WATERVIEW EAST COMMERCIAL

WATERVIEW EAST COMMERCIAL FILING NO. 1
CONSTRUCTION DOCUMENTS
COVER SHEET

Subject: Text Box
Page Label: [1] C0.0 COVER SHEET
Author: CDurham
Date: 11/4/2026 2:43:54 PM
Status:
Color:
Layer:
Space:

SHEET
C3.2

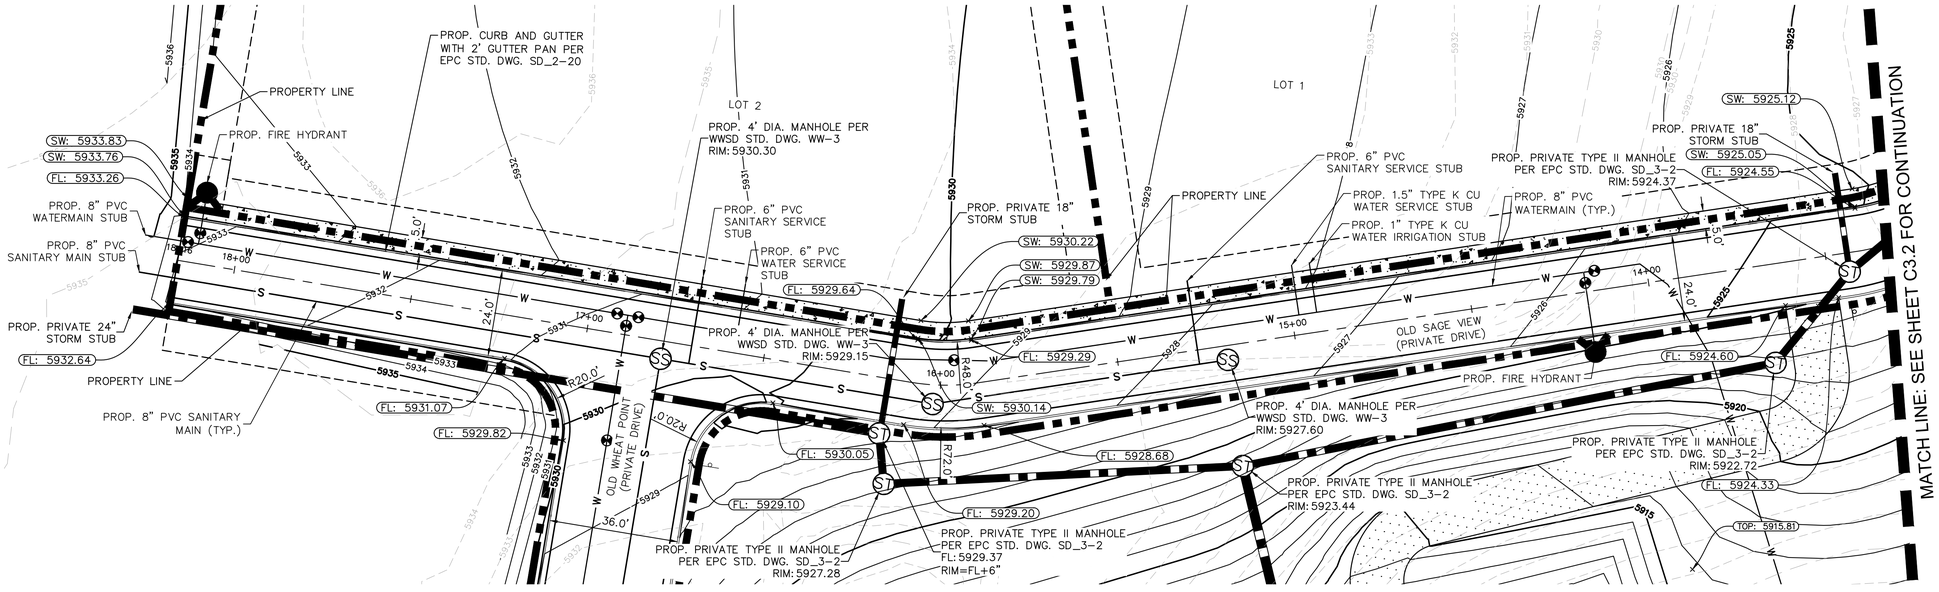
Provide road profile

SHEET
C3.3

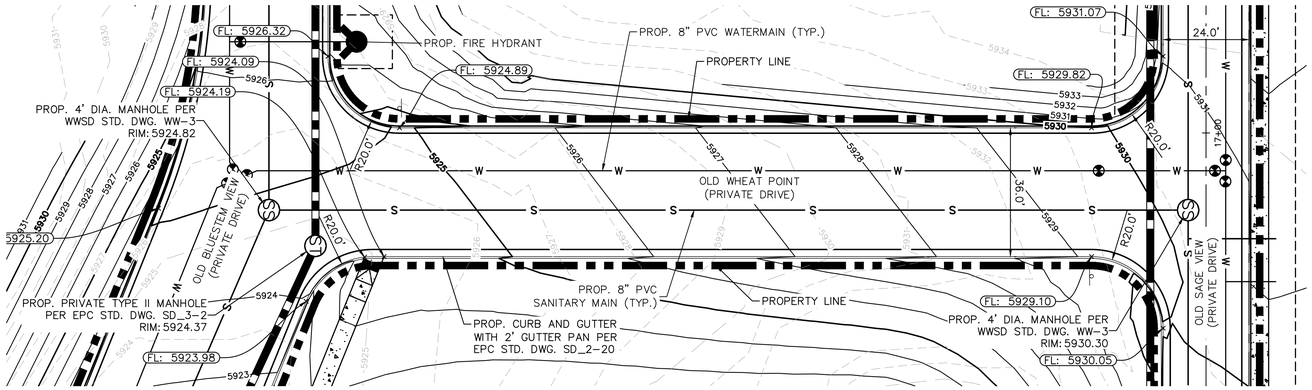
Provide road profile

SHEET
C3.4

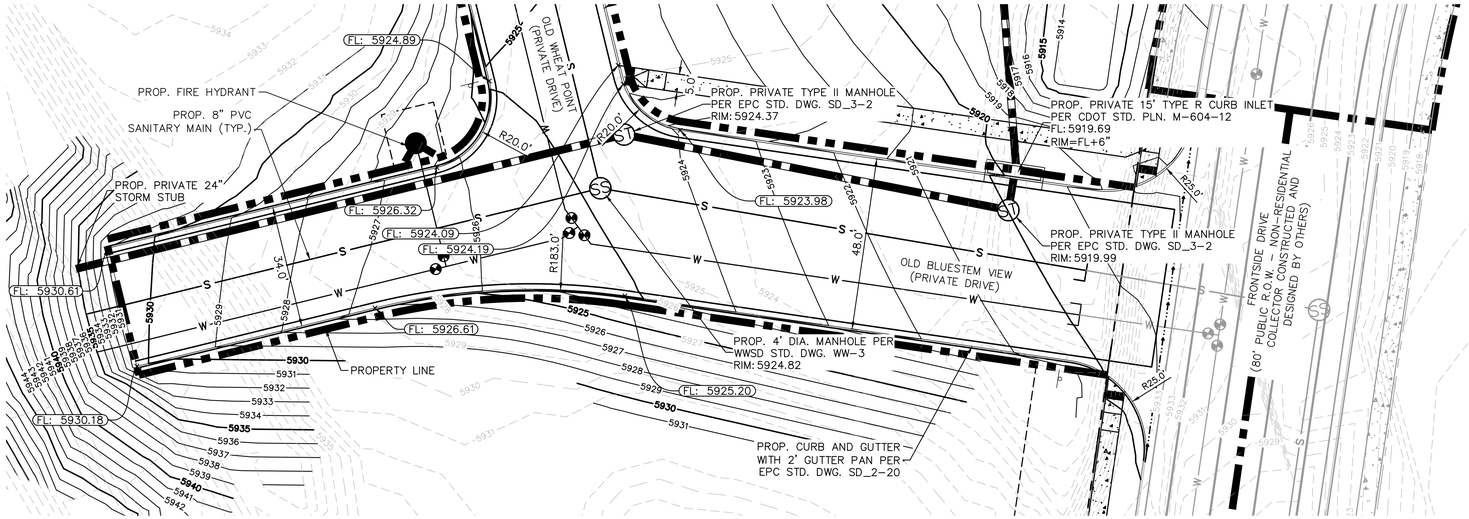
Provide road profile

11 FOREBAY B PLAN VIEW
VOL = 75.0 CF

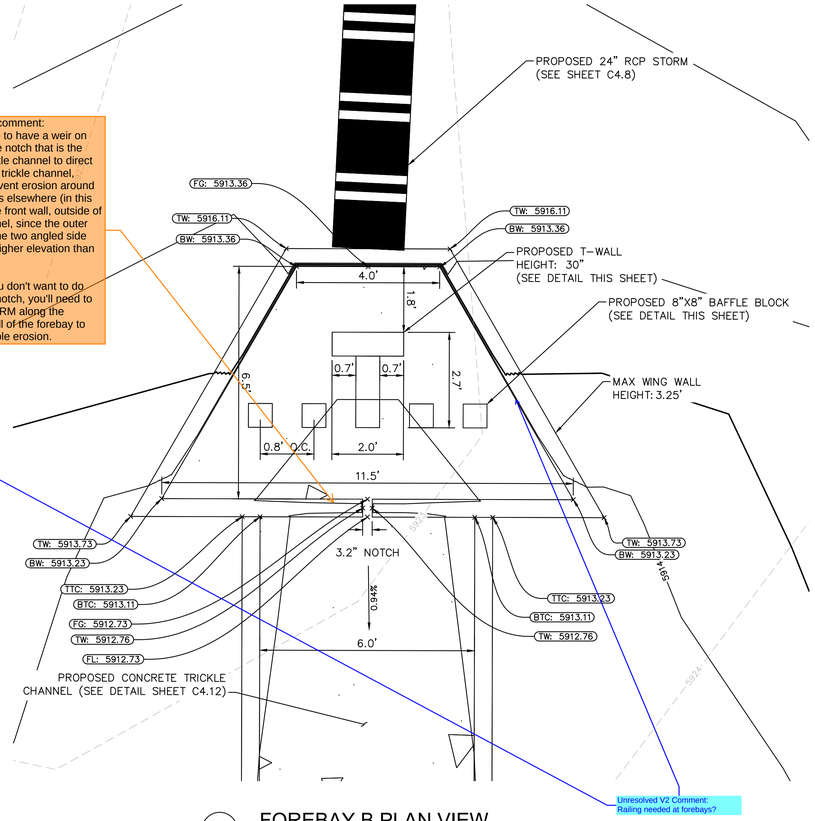
Unresolved V2 comment:
It's best practice to have a weir on both sides of the notch that is the width of the trickle channel to direct overflows to the trickle channel, which helps prevent erosion around the forebay walls elsewhere (in this case, just on the front wall, outside of the trickle channel, since the outer forebay walls (the two angled side walls) are at a higher elevation than the front wall).

V3 update: if you don't want to do this secondary notch, you'll need to have riprap or TRM along the downstream wall of the forebay to stop the inevitable erosion.
